# Greenhouse Gas Emissions Accounting for the Demolition of the Existing Cambridge Waste Water Treatment Plant

**Save Honey Hill****Written Representations: Appendix C Design Critique****Introduction**

This critique has been written by two former principals of nationally known architectural practices, members of SHH, long term residents of Horningsea and Fen Ditton respectively. As well as many years in mainstream practice they have also taught design in university schools of architecture in Cambridge, London and Oxford.

**Fig 3 : Interruption to long views.**

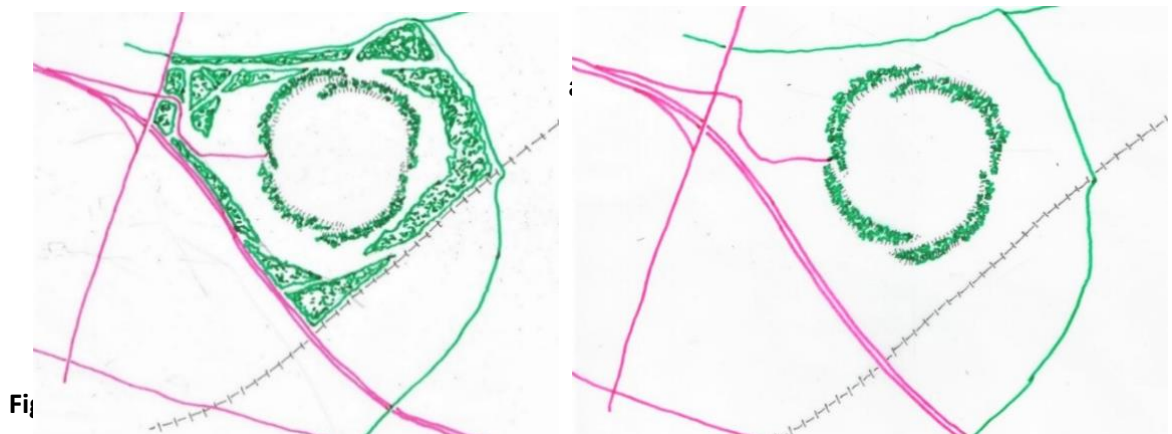
- d) The intensive block of tree planting proposed on and all around the bund which in turn is surrounded by further blocks of trees constitutes a large agglomeration and an incongruous element in this landscape.

Fig 5: Contour Study

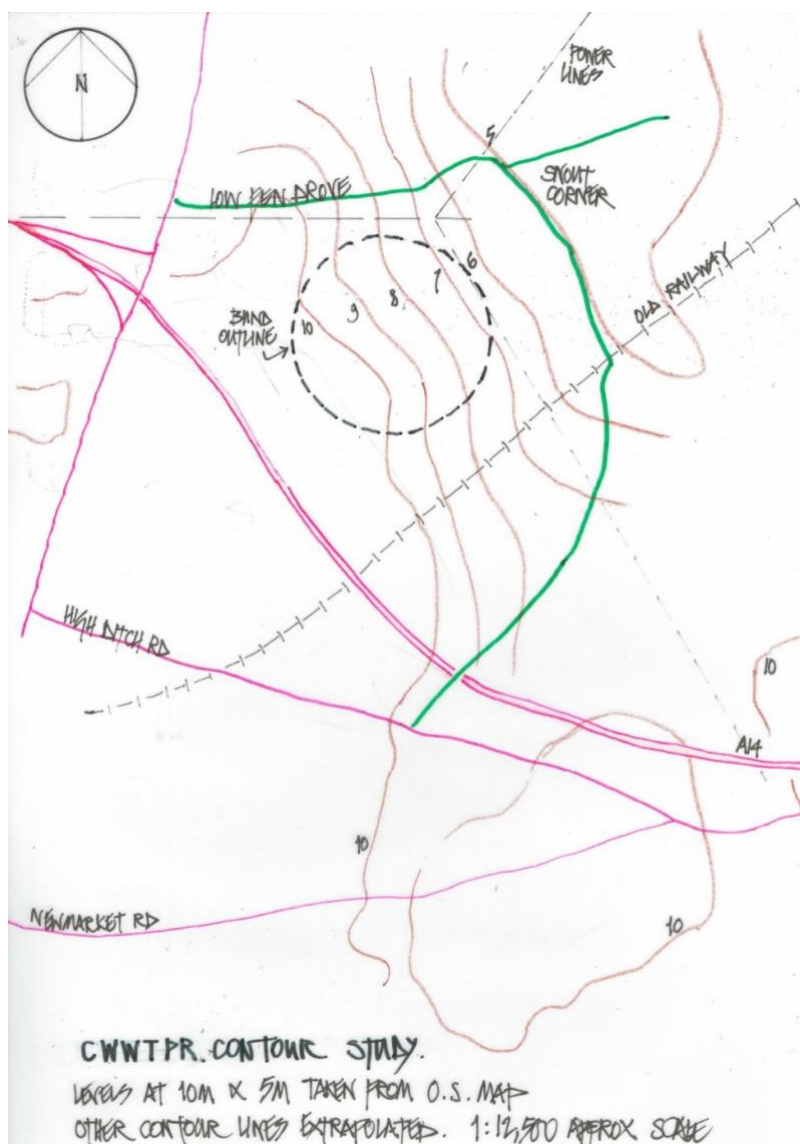
- a) By raising the ridge line many of the structures could be readily concealed from adjoining communities and principal routes, greatly reducing reliance on planting. This result could be enhanced if the existing dead ground east of the brow, provided by the 4-5 metre fall between the ridge and Snout Corner, was added to the concealing effect of the raised ridge.

### **Fig 7: View of tree belt along Low Fen Drove Way**

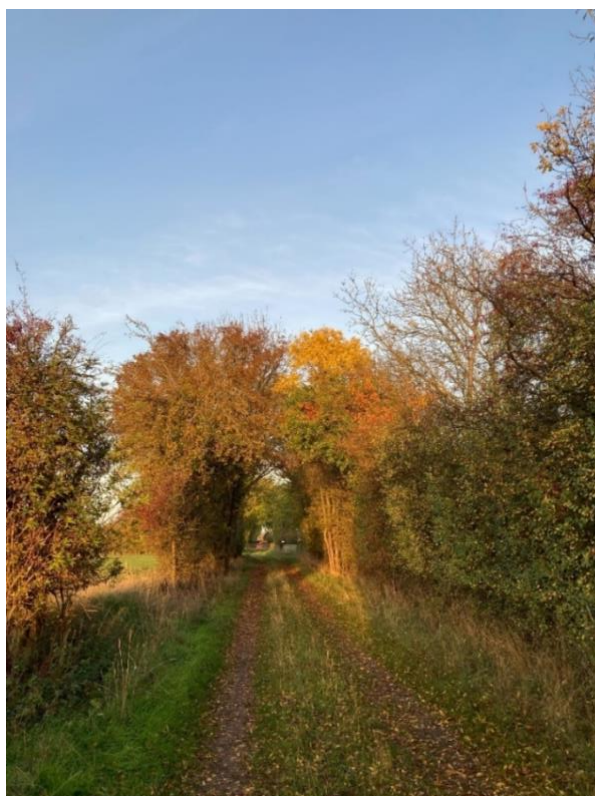
- b) Further, existing well established and substantial screening, provided by the trees flanking Low Fen Drove Way between the former level crossing and the derelict black barn could be used to screen the site from the east. The remnants of hedgerows beside the disused railway could also provide ready-made and readily thickened screening from the southeast.

**Figure 10: Existing Hedges and Tree belts**

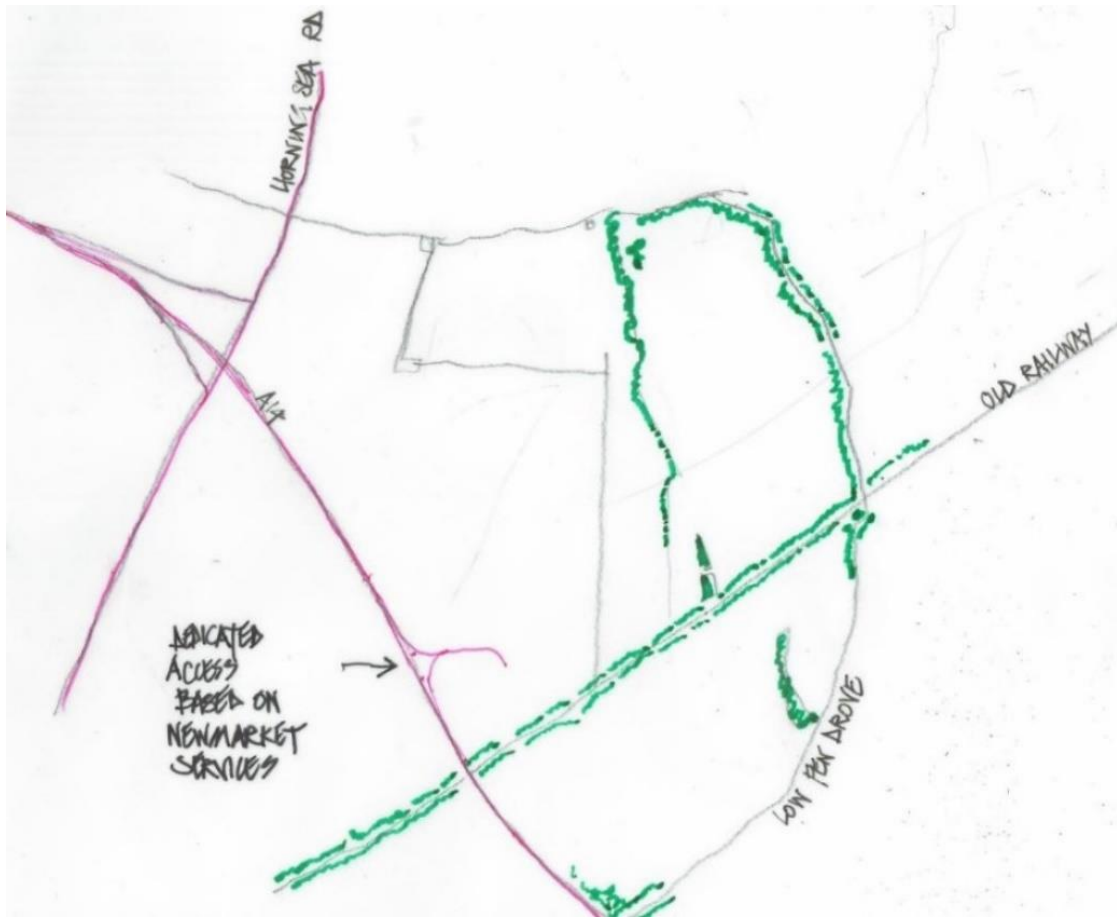
- a) SHH favours this but believes the best way to do this is to have a dedicated vehicular access off the A14, which in turn can be made a safer highway at this point.

**Fig 11: Existing recreational routes and water courses**

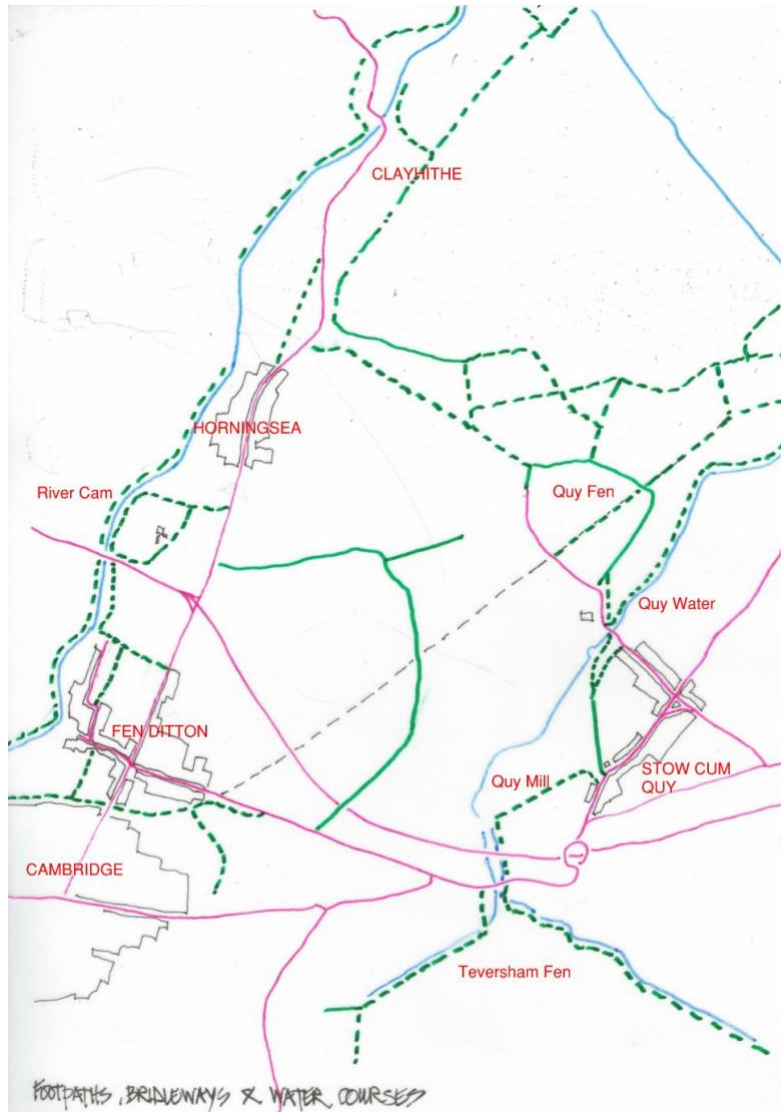
- a) Mindful of the impending increase in the residential population in the adjacent quarter of the city, SHH favours improving links to and enhancing the network of fine recreational routes available.

- b) The return to bridleway status of the disused railway track between Low Fen Drove and Station Rd Quy is no particular achievement as many people currently have the landowner's permission to use this route.
- c) The routes proposed across the area adjacent to the plant are similarly not to be greatly valued as they only shorten the route currently provided by Low Fen Drove Way and pass through an area which will not be considered salubrious.

**Fig 12 : Proposed new path ways (shown in red)**

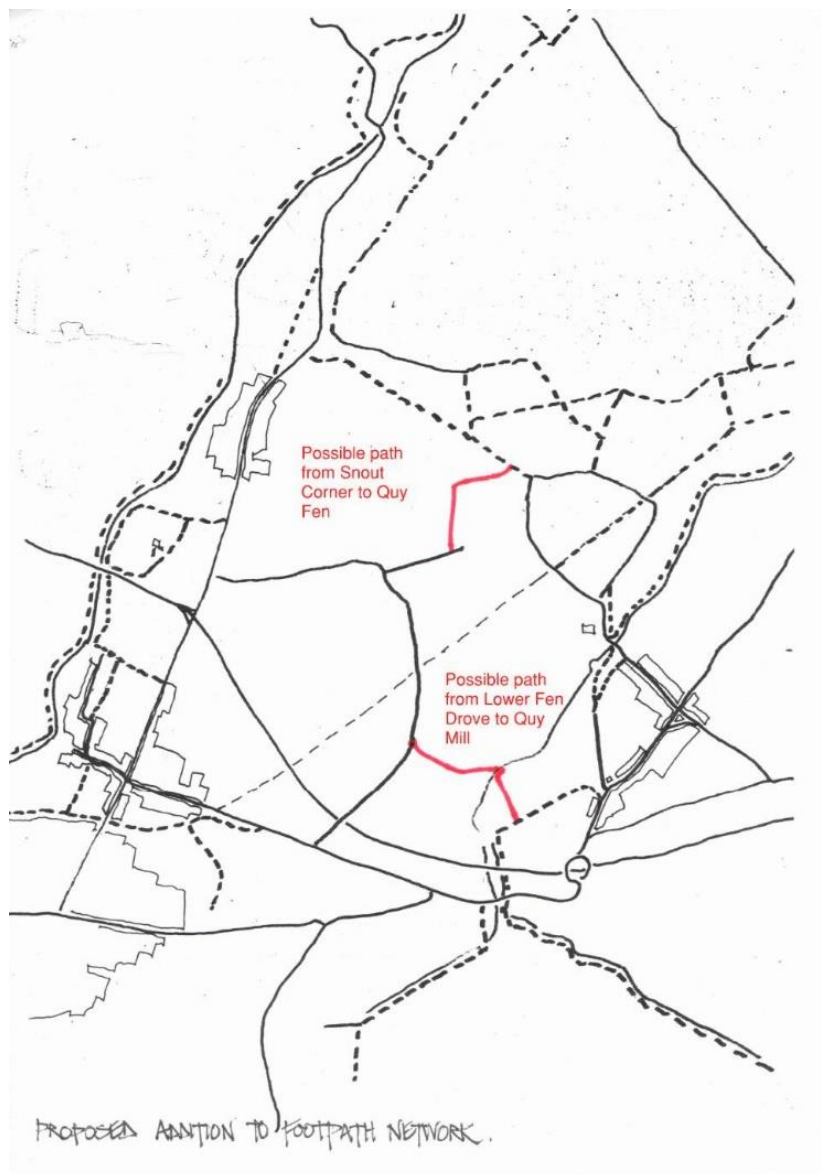
- d) Preferable would be an arrangement with the landowner to allow permitted pathways along existing tracks from Snout Corner to Allicky Farm connecting to Quy Fen and from the southerly end of Low Fen Drove linking round to Quy Mill and Stow-cum-Quy village.
